B. DRAWINGS

Substitute formal drawings are submitted herewith. The drawings will be submitted separately to the Official Draftsman upon approval of the Examiner in this case.

Fig.4.

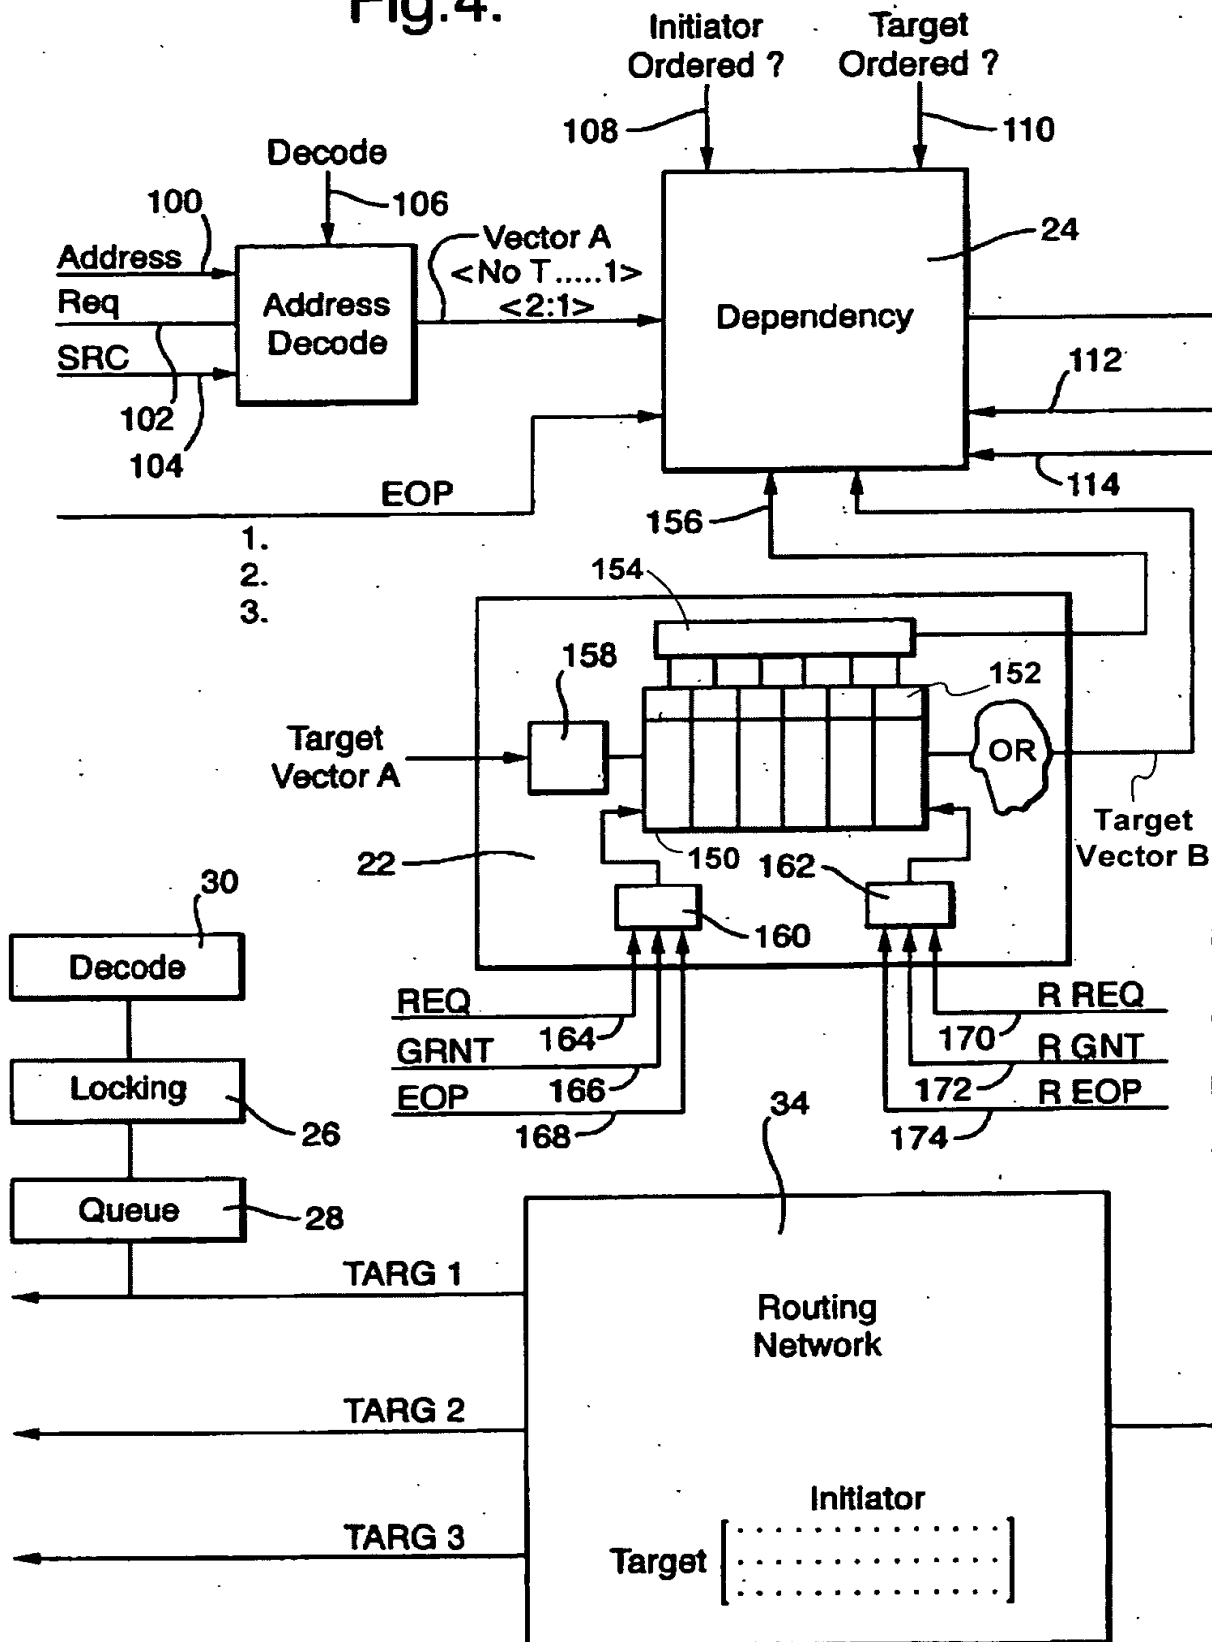
Figure 4 is amended to label elements 150, 152, 154, an "OR" logic element and "Target Vector B" to be consistent with the specification as filed. Fig. 4(cont) is corrected to label element 25, to correctly draw a line between element 184 and the signal line labeled 190, and to correctly label "Resource vector D" so as to correspond to the description in the specification. Fig. 5 is amended to correctly label elements 28 and 30 to be consistent with the specification. No new matter is added by these corrections to the drawings.
